YARRA CITY COUNCIL **Internal Development Approvals Committee** Agenda to be held on Wednesday 20 November 2019 at 6.30pm in Meeting Rooms 1 & 2 at the Richmond Town Hall **Rostered Councillor membership Councillor Stephen Jolly** Councillor Bridgid O'Brien Councillor Mi-Lin Chen Yi Mei (substitute for Cr James Searle) Ι. **ATTENDANCE** Amy Hodgen (Co-ordinator Statutory Planning) Chris Stathis (Senior Statutory Planner) Cindi Johnston (Governance Officer) DECLARATIONS OF PECUNIARY INTEREST AND CONFLICT OF П. INTEREST III. **CONFIRMATION OF MINUTES**

1.1 PLN18/0579 - 152 - 154 Keele Street, Collingwood - Demolition of the existing dwelling to allow for the construction of two dwellings, one on each allotment, and a reduction in the car parking requirement of the Yarra Planning Scheme.

1. This report provides Council with an assessment of Planning Permit Application PLN18/0579 which affects land at 152 and 154 Keele Street, Collingwood and recommends approval of the submitted proposal, subject to conditions.

Figure 9: Extract from Council's heritage advice showing the MMBW map dated 1902.

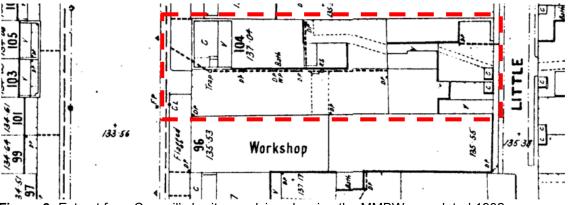
52. The new dwelling is double-storey (plus roof terrace) and has been located towards the rear of the subject site, providing a front setback of 11.07m. Whilst not typical of older housing stock in the area (which generally have shallow front setbacks), the siting of the new dwelling is supported as it is consistent with the historic siting of the site. A map produced by the MMBW (which dates back to 1902) shows that the southern portion of the subject site did not have built form presenting to the street. The generous front setback proposed by the new dwelling is therefore consistent with the historic layout of the site. In addition, the proposed siting of the new dwelling ensures that it will not be overwhelmingly visible from the street and will ensure that the existing, contributory dwelling remains prominent in the visual hierarchy. Finally, Council's Heritage Advisor was supportive of the front setback proposed.

Figure 10: Section showing the difference in height between the southern clerestory element of the new dwelling and the boundary fencing associated with No 100 Gore Street.

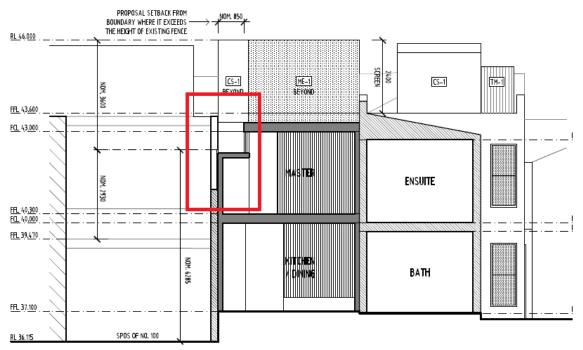
- (b) The southern clerestory element of the new dwelling is proposed to be located opposite the SPOS of No. 100 Gore Street, however there will not be any unreasonable visual bulk impacts due to the very high boundary fencing separating the two sites – 6.29m as measured from No. 100 Gore Street (or approximately 5.3m as measured from the subject site). The southern clerestory element will exceed the height of the boundary fence by only 1m as shown at figure 10.

REGARDING THE SECOND DWELLING AT No. 102 GORE STREET

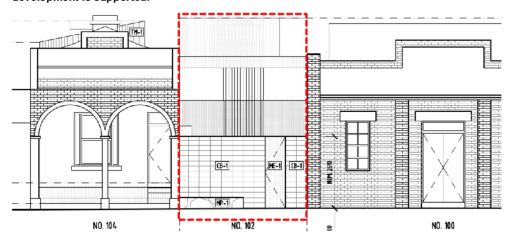
The proposed front setback for the new dwelling will be 11metres from the front boundary. The setback is beyond the front two rooms of the existing building, and meets the sightline analysis diagram in Clause 22.02-5.7.1 Figure 1. **The proposed front setback is supported.**

Roof form:

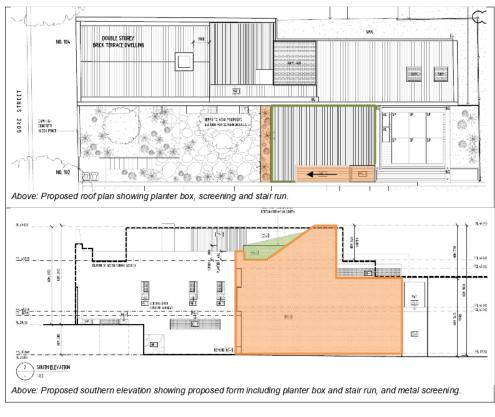
The proposed development will have a roof terrace, including planter box and stair run above the roof. As such there will be a number of forms.
